45.7009.R1/GA/DT/2015

Mr Marino Ferlazzo
67 Tallawong Road
ROUSE HILL NSW 2155

28 September 2015

REVIEW OF ACOUSTIC PLANNING ISSUES
SYDNEY METRO NORTHWEST
RAPID TRANSIT RAIL FACILITY

Figure 4. Indicative Land Planning Map for Riverstone East

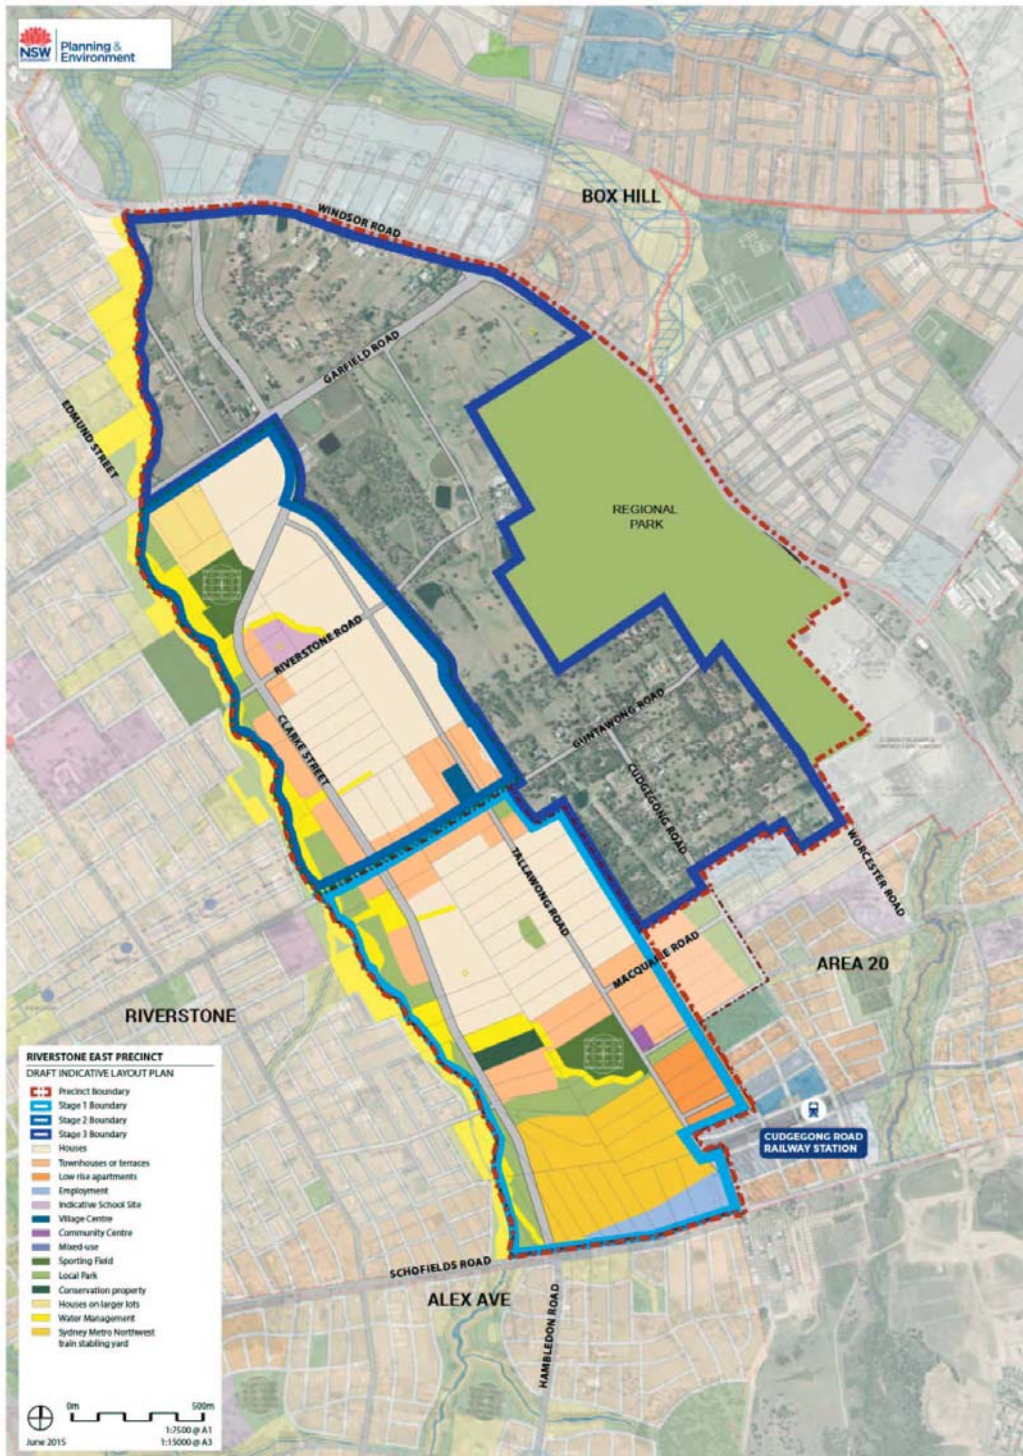
The Renzo Tonin Report dated 24 March 2015 (Tonin) was prepared to address noise impacts referenced to an Indicative Layout Plan (ILP) for the Riverstone East Precinct. Tonin reports that the ILP was prepared with consideration of the potential noise impacts resulting from the proposed land use changes. *Figure 4* provides a copy of the ILP. Tonin (Section 1) reports that the aim of the noise assessment was to identify any potential constraints on future development resulting from existing land uses and surrounding the Precinct, as well as provide recommendations and controls for future development.

Tonin (Section 3) refers to the latest ILP (*Figure 4*) and reports that it has resulted in a reduction of potential land use conflicts, in particular through effective use of open space buffers and reduction of residential development interfacing with noise sources. In our opinion Tonin has not considered the RTRF Approval Conditions, noise and vibration emission from the RTRF and the North West Rail Line for existing residential development to the north of the RTRF, including 67 Tallawong Road.
